REMARKS

Claims 1-19 are pending in the application. It is gratefully acknowledged that Claims 4-7, 10-14 and 17-19 have been objected to as being dependent upon a rejected base claim, but would be allowable if rewritten in independent form to include all of the limitations of the base claim and any intervening claims. The Examiner objected to the drawings for failing to comply with 37 C.F.R. 1.84(p)(5) for including reference character(s) not mentioned in the description. The Examiner objected to Claims 3 and 12 for informalities. The Examiner has rejected Claims 1, 3, 8 and 15 under 35 U.S.C. §102(e) as being anticipated by Parsa et al. (U.S. Patent 6,643,318). The Examiner has rejected Claims 2, 9 and 16 under 35 U.S.C. §103(a) as being unpatentable over Parsa et al.

FIG. 13B

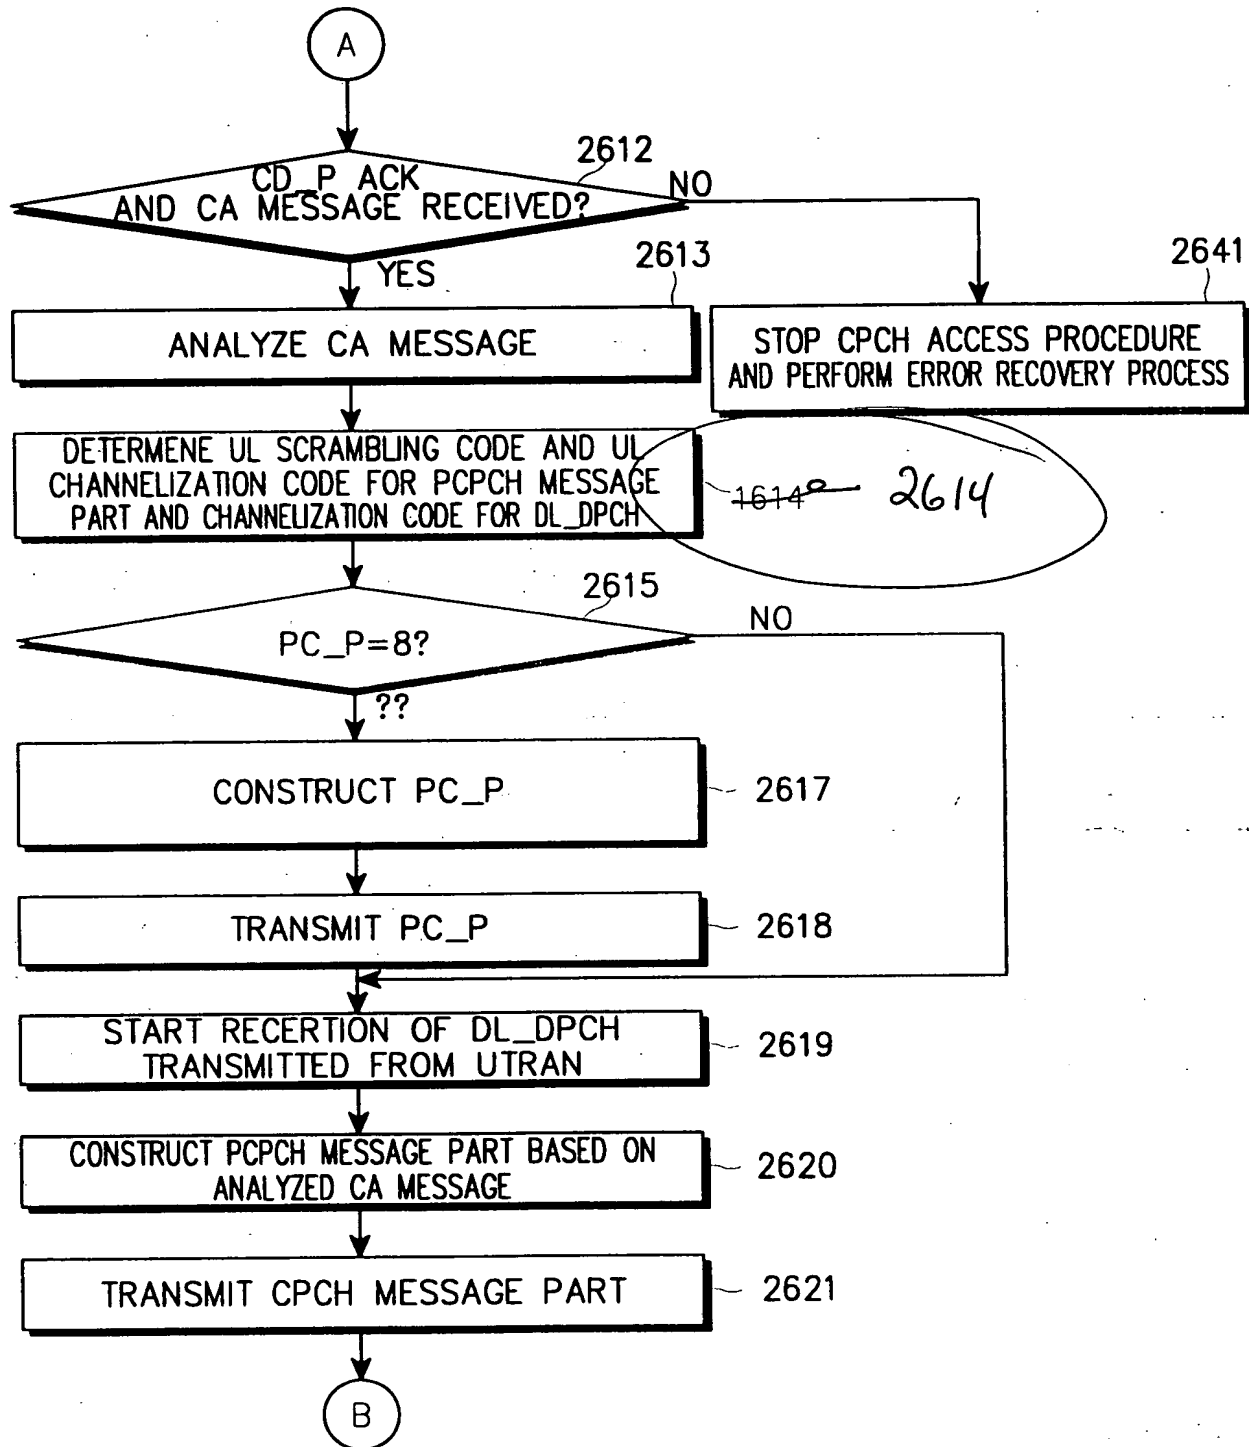
Regarding the objections to be corrected via amendments to the drawings, the Examiner stated that reference numerals 1330 and 1340 in Fig. 13B, and reference numeral 1614 in Fig. 26B are not mentioned in the description, and reference numeral 3241 is mentioned in the description but not shown in a drawing. Attached hereto are amended Figs. 13B, 26B and 32, in both a clean and a marked-up version. Reference numerals “1330” and “1340” have been removed from Fig. 13B as shown. Reference numeral “1614” in Fig. 26B has been changed to read “2614” as shown. Reference numeral 3241 has been added to Fig. 32 as shown. In addition, in Fig. 32, the spelling error of “Error” has been corrected to read “Error” in block 3241 as shown. Withdrawal of the objections to the drawing is respectfully requested.
